The Commission has issued the enclosed Amendment No. 97 to Provisional Operating License No. DPR-20 for the Palisades Plant. This amendment consists of changes to the Technical Specifications in response to your application dated March 17, 1986.

This amendment changes the Technical Specifications by revising pressure-temperature limits for heatup, cooldown and hydrostatic tests of the reactor vessel to account for radiation effects. This amendment also extends the limits from 6.6 effective full power years to approximately 9.0 EFY.

Amendment No. 97  
License No. DPR-20

SAFETY EVALUATION BY THE OFFICE OF NUCLEAR REACTOR REGULATION  
RELATED TO AMENDMENT NO. 97 TO PROVISIONAL OPERATING LICENSE NO. DPR-20  
CONSUMERS POWER COMPANY  
PALISADES PLANT  
DOCKET NO. 50-255

Paltades Plant Pressure/Temperature Limits for Hydro  
 for Fluence to 1.8 x 10<sup>19</sup> nvt  
 Figure 3-3

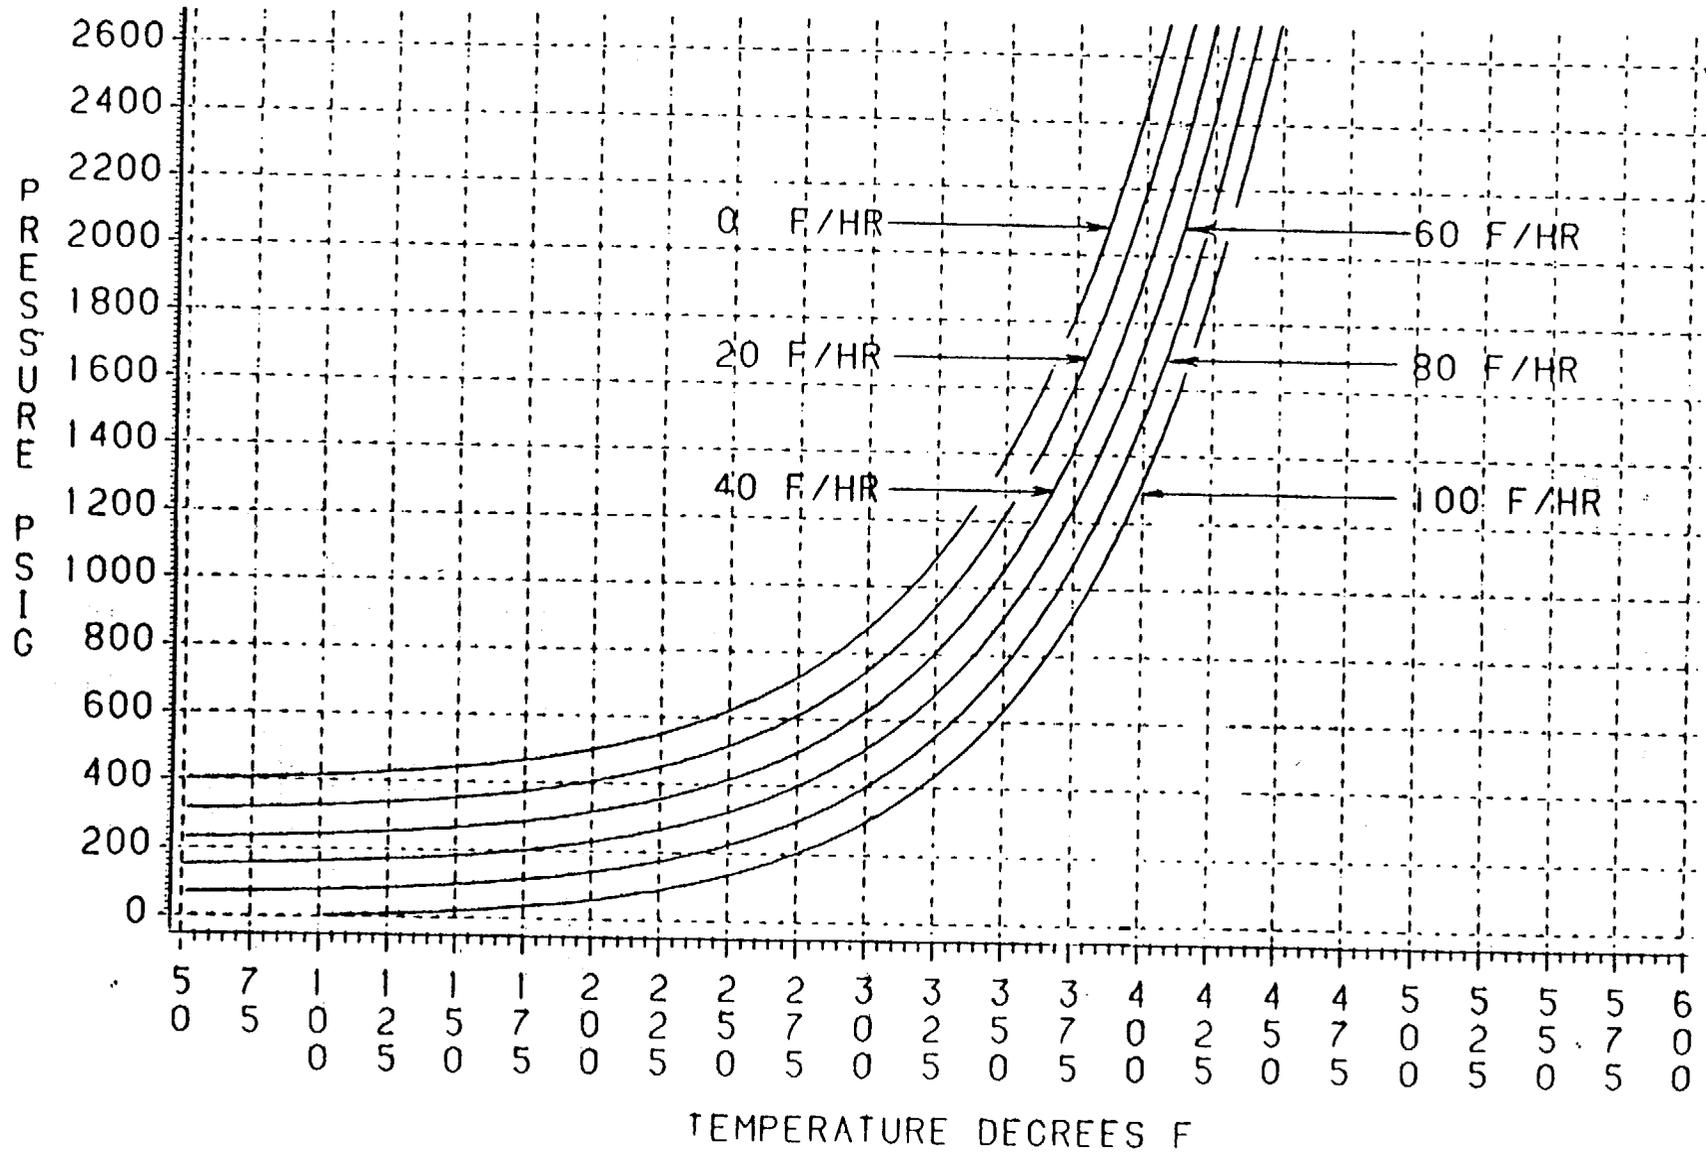
- c) Allowable combinations of pressure and temperature for inservice testing from heatup are as shown in Figure 3-3. Those curves include allowances for the temperature change rates noted above. Interpolation between limit lines for other than the noted temperature change rates is permitted in 3.1.2a, b or c.

The criteria from Section III, ASME Code, Article G-2000, Vessels, was used to determine the measured temperature during an inservice hydrostatic test ( $K_{IR} \geq 1.5K_{Im} + K_{It}$ ). At the flaw on the inside surface of the longitudinal weld, the temperatures computed by the staff and the licensee are essentially the same for the hydrostatic test pressure of 2310 psig. The minimum criticality temperature of 371°F computed by the licensee is acceptable. The family of curves for pressure-temperature limits for inservice hydrostatic testing is acceptable to the staff.

Palisades Plant Pressure/Temperature Limits for Heatup  
 for Fluence to  $1.8 \times 10^{19}$  nvt  
 Figure 3-1

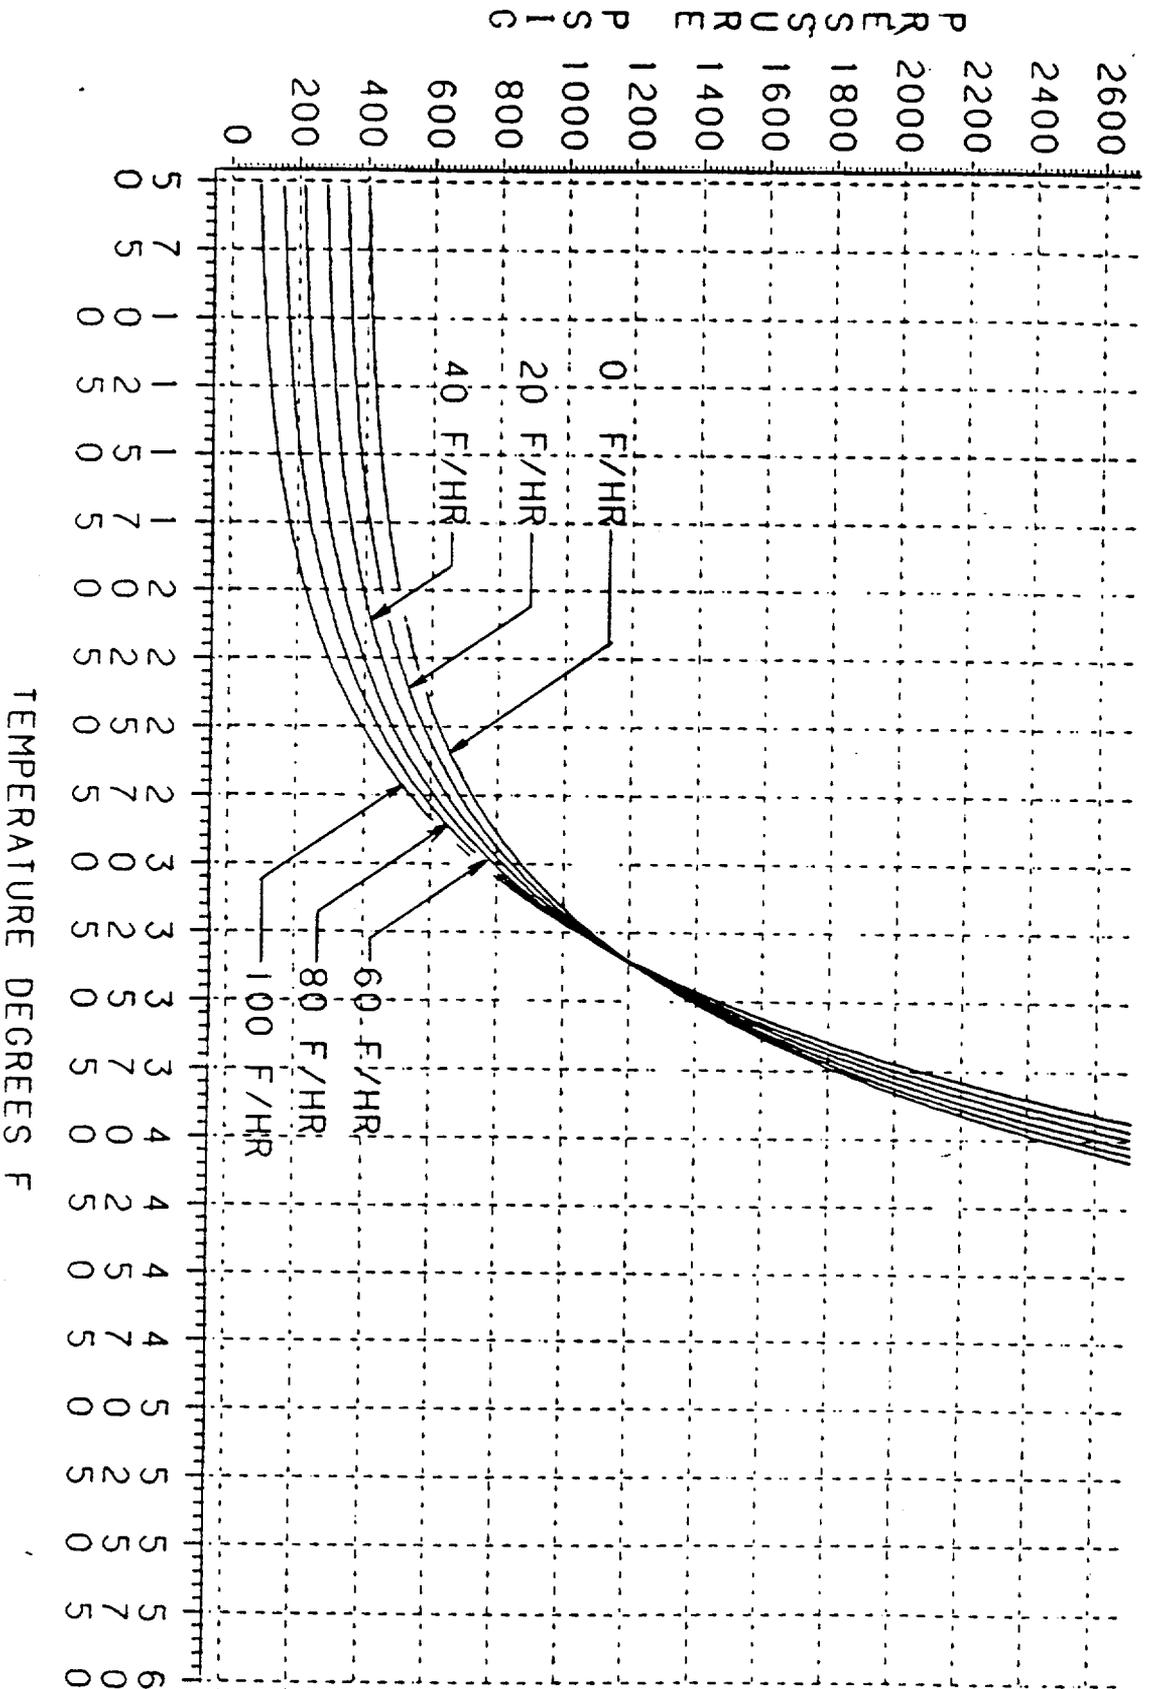
- a) Allowable combinations of pressure and temperature for any heatup rate shall be below and to the right of the limit lines as shown on Figure 3-1. The average heatup rate shall not exceed 100°F/h in any one-hour time period.

Figures 3-1 and 3-2 of the licensee's submittal do not include pressure-temperature limits for heat-up and cool-down during core operations; that is, these figures are for the reactor noncritical during heat-up and cool-down. Pressure-temperature limits for heat-up and cool-down during core operations are obtained by adding 40°F to the temperature values in Figures 3-1 and 3-2. The resulting temperature must be greater than or equal to the minimum criticality temperature, 371°F.

The criteria from Section III, ASME Code, Article G-2000, Vessels, was also used to determine the measured temperature during various heat-up and cool-down rates ( $K_{IR} \geq 2K_{Im} + K_{It}$ ) of the reactor vessel. For heat-up, either the flaw in the longitudinal weld on the inside surface (1/4 thickness) or the outside surface (3/4 thickness) is limiting. For cool-down, the flaw in the longitudinal weld on the inside surface (1/4 thickness) is limiting. The family of heat-up and cool-down curves (0°F/hr through 100°F/hr) computed by the licensee either conservatively bound the values calculated by the staff or differ by 2% or less. The differences in computed temperature values between the licensee and the staff are due to (1) the expressions used to attenuate the neutron fluence, (2) the methodology used to determine the temperature gradient through the vessel wall, and (3) whether  $K_{It}$  is disregarded when it would be conservative to do so. Thus, the staff finds the pressure-temperature limits for the family of heat-up and cool-down curves presented by the licensee to be acceptable.

Palisades Plant Pressure/Temperature Limits for Cooldown  
 for Fluence to  $1.8 \times 10^{19}$  nvt  
 Figure 3-2

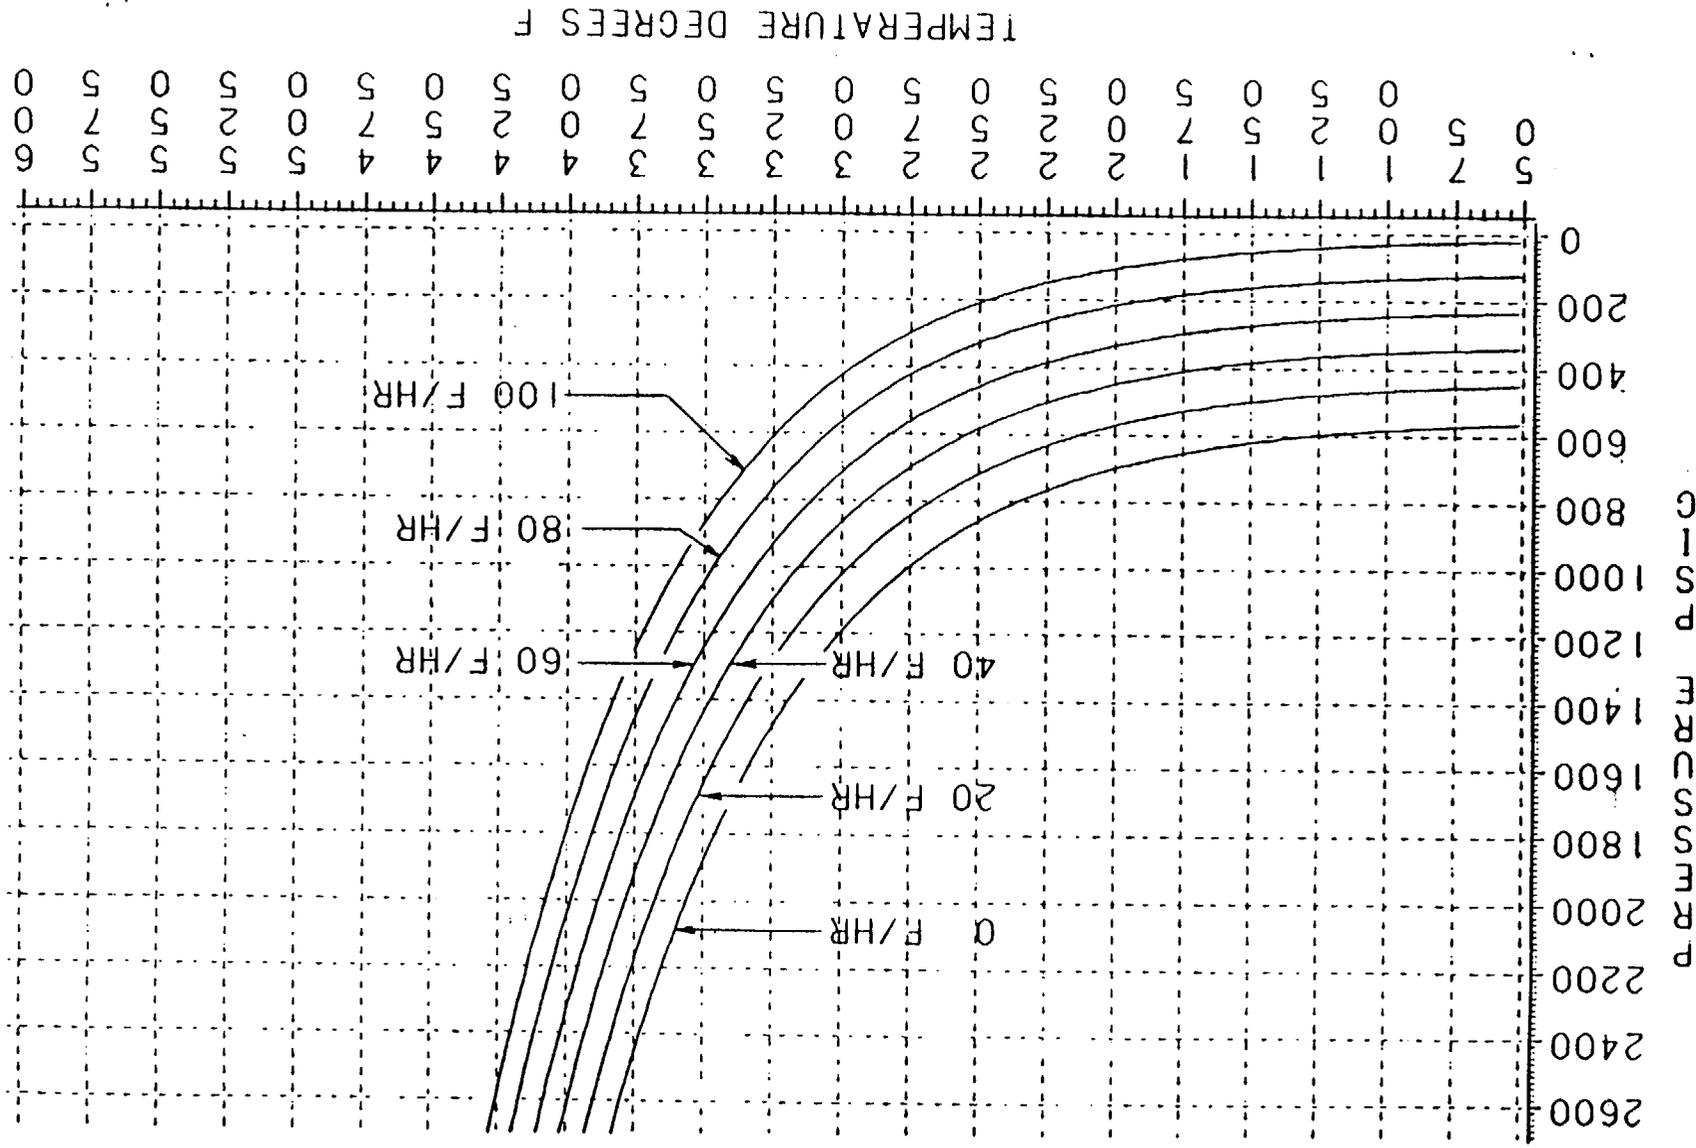
- b) Allowable combinations of pressure and temperature for any cooldown rate shall be below and to the right of the limit lines as shown on Figure 3-2. The average cooldown rate shall not exceed 100°F/h in any one-hour time period.
